Supplementary Report on Groundwater

**Lower Lee (Cork City)
Flood Relief Scheme**

Supplementary Report –
Groundwater/Hydrogeology

230436-00

Figure 1: Investigative locations on City Island

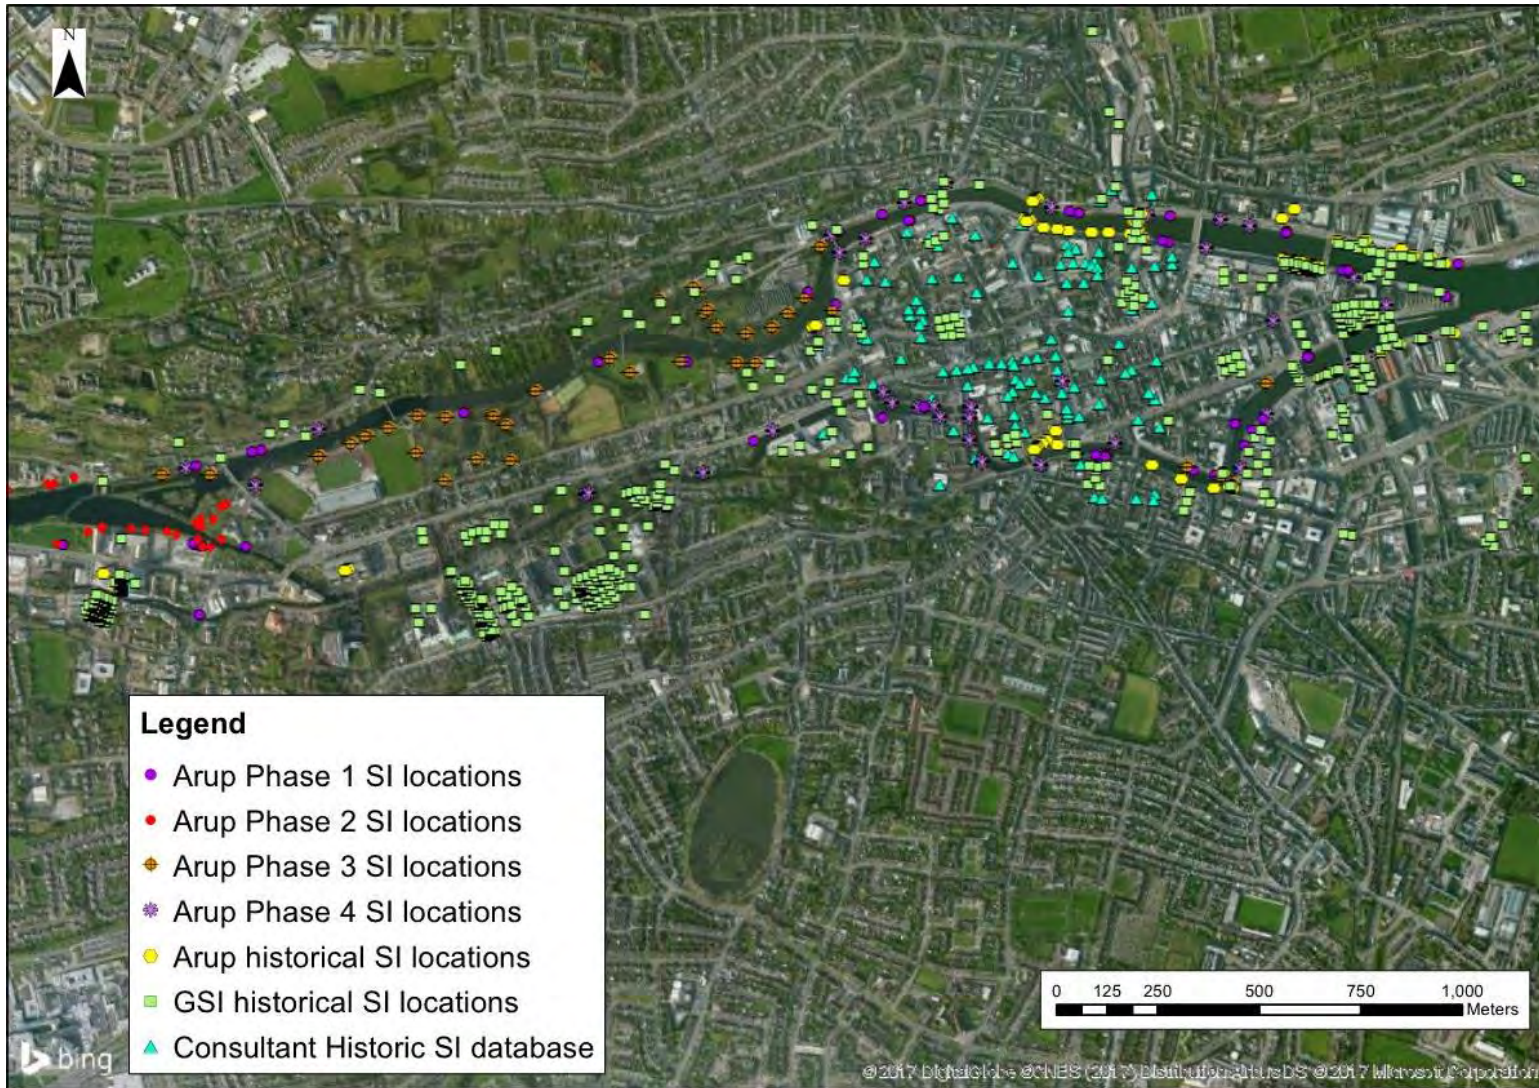
A number of submissions queried how uncertainty beneath the ground is being addressed in the assessments, specifically for parameters such as groundwater levels. Similarly, queries were raised whether groundwater levels were being monitored adjacent to the river banks only, or whether data is available in the wider City Island area.

As outlined in Appendix A, an extensive volume of information is available for the City Island from publicly available sources, academic research, previous projects and site-specific investigations. These investigations are also ongoing through the detailed design phases to ensure any data gaps arising out of changes in the design are addressed for the final design.

Figure 1 illustrates the significant volume of information available across the City Island. Figure 2 presents the number of groundwater and river water monitoring wells currently located across this area (shown in red), and additional wells that will be installed (shown in orange and yellow).

Figure 1 (and Table 1) presents a location map of investigative locations on the City Island. This demonstrates the extensive dataset that has been developed and is being used in the detailed design process.

Figure 3: Location of the conceptual cross section B-B' and summary of data available for Cork City Island used in the development of the conceptual model

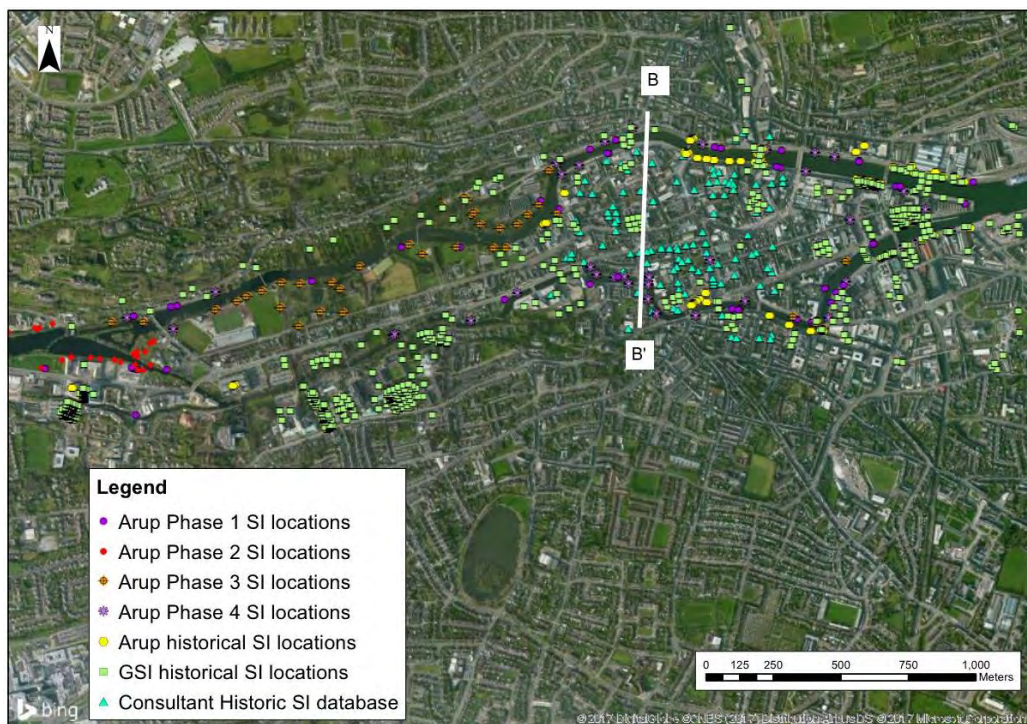
7. Where has groundwater monitoring been undertaken and was it limited to the vicinity of the two river channels? Does it capture tidal information, what is tidal max and min, where does it occur and why?

8. What is the influence of tidal lag?
9. How and where will water be diverted?

Submission		Response
6	Are there any vulnerabilities in the upper aquitard layer (of made ground and silt/alluvium) and how will that be addressed? E.g. has heterogeneity in ground conditions – natural/manmade been considered?	<p>As outlined in Sections 3 and 4, the upper aquitard layer is not consistently present across City Island. This has been considered in the modelling, as outlined in Appendix C, by running scenarios where the silt (alluvium) is present and not. The influence of this on groundwater levels has been addressed in Section 4.</p> <p>The ground models used to build the numerical models include the site-specific heterogeneity based on ground investigation information at each location. A conservative approach has been taken where no site-specific data is available, or the investigations are ongoing.</p>
7	Where has groundwater monitoring been undertaken & was it limited to the vicinity of the two river channels? Does it capture tidal information, what is tidal max/min - where and why.	<p>The groundwater monitoring network is identified in Section 3. Due to access restrictions for the first phases of ground investigation, these focused on the river channels. However, additional groundwater monitoring wells are in the process of being installed across the wider City Island.</p> <p>The extent of the tidal influence on the river channel and groundwater is presented in Figure 2.</p>

- The rate and degree to which groundwater responds to river/tidal water, defined as the tidal lag, varies across City Island. The tidal lag has been generalised into three zones shown in Figure 2, ranging from areas of greater groundwater response in Zone 1 to areas of lower groundwater response in Zone 3. Note, even in areas of greater groundwater response, groundwater level change is delayed and less than that observed in the river/tide. The cause of this varying groundwater response to tidal and river water levels can be affected by:

In Zone 1 the response is greatest (with a groundwater response of 80 - 90% of the tidal response and a lag time of 1 to 1.5hr), Zone 2 the groundwater response reduces to 70% and Zone 3, groundwater levels change the least or approximately 50% of the tidal change respectively.

Figure C2: Model (with alluvium & made ground) output of tidally dominated flood event when peak groundwater levels occur

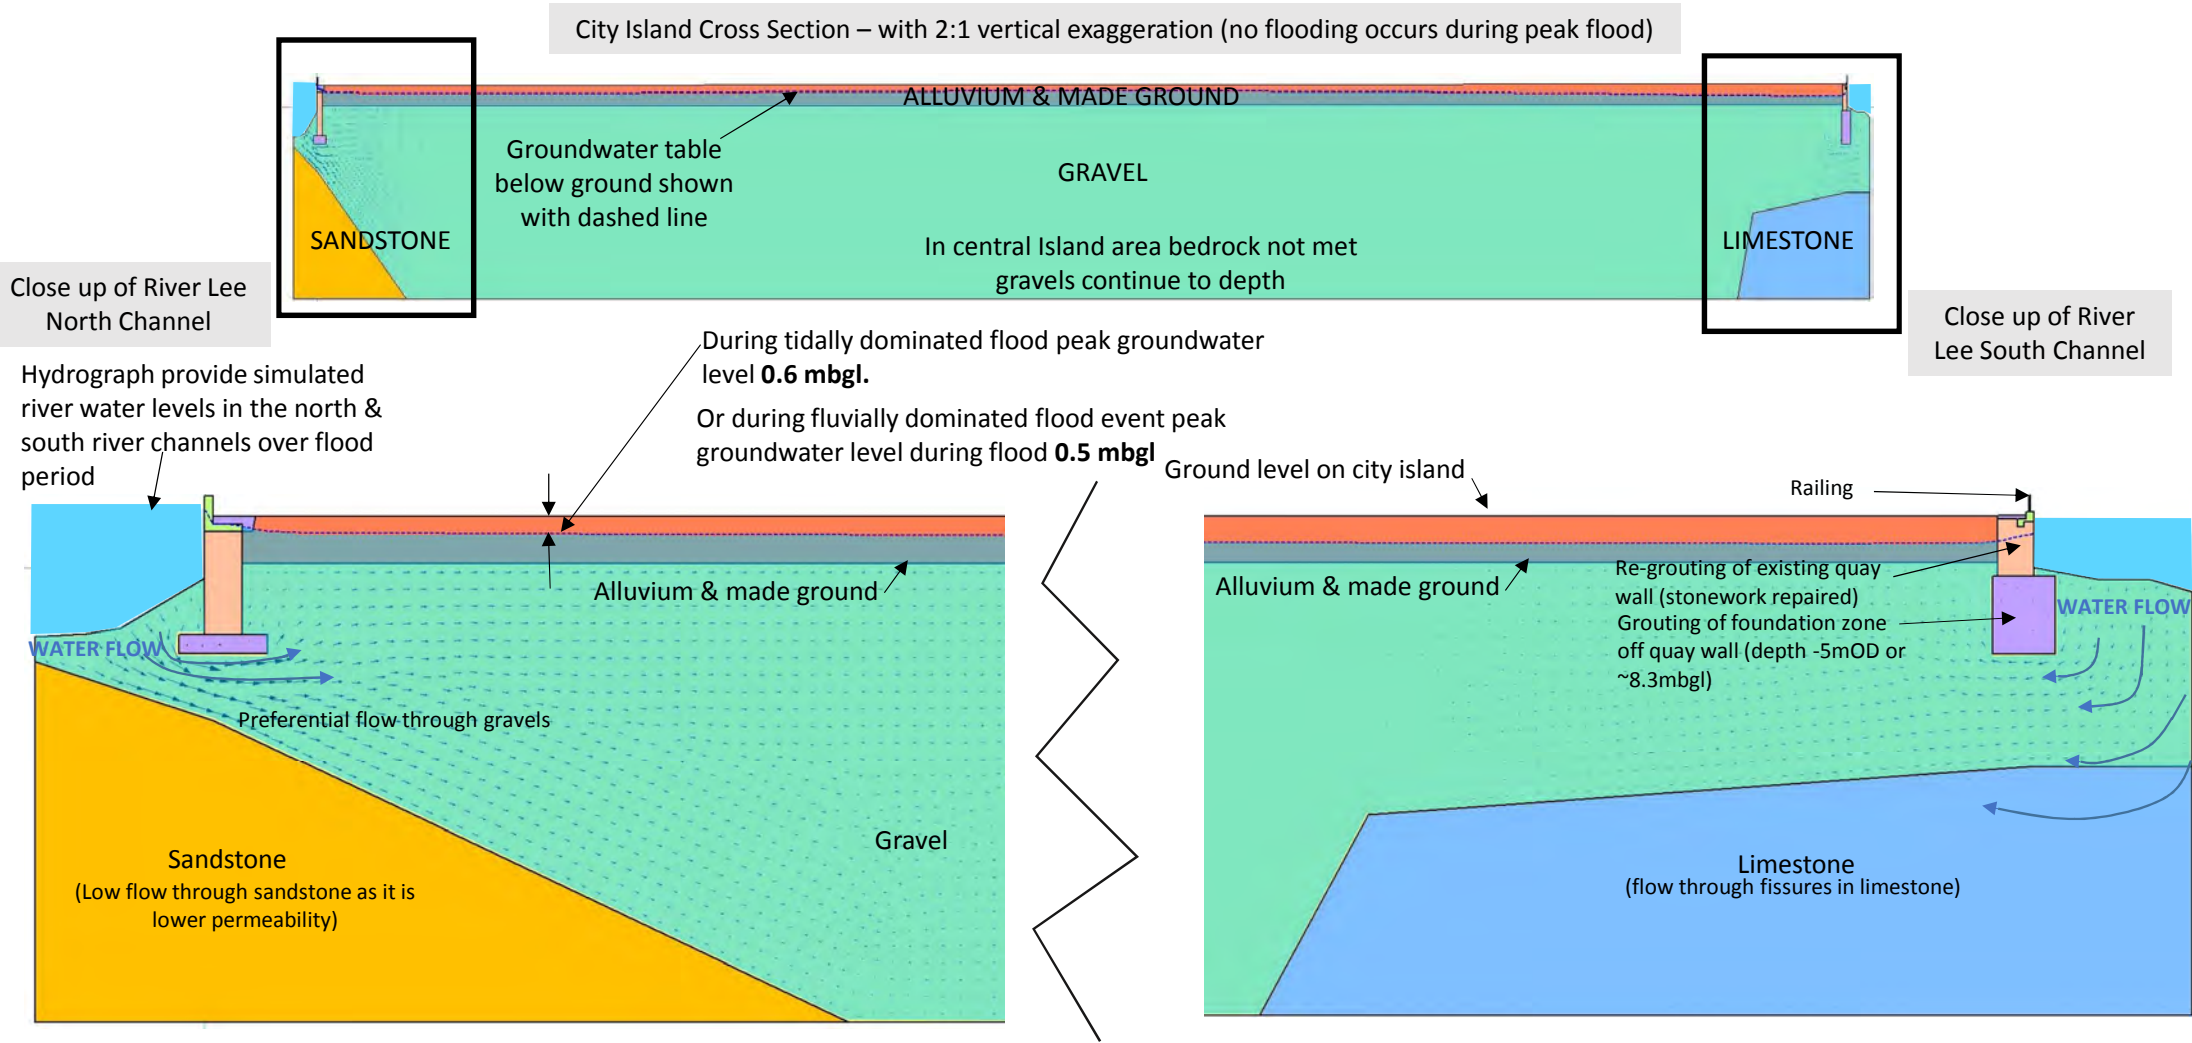
During flood conditions, the potential for river water to move beneath the flood defence walls, causing groundwater levels on City Island to rise and result in flooding, has been raised in a number of submissions.

Figure C1 below shows the location of the City Island section that has been analysed using SEEP-W 2D finite element model. Two model outputs are presented for this area (see Figure C2 & C3 below).

The models include; a complete cross section of City Island from North Channel to the South Channel, the proposed flood defence and two ground conditions scenarios. Close-ups of the flood defence sections on the North and South Channel have been provided so more detail can be seen.
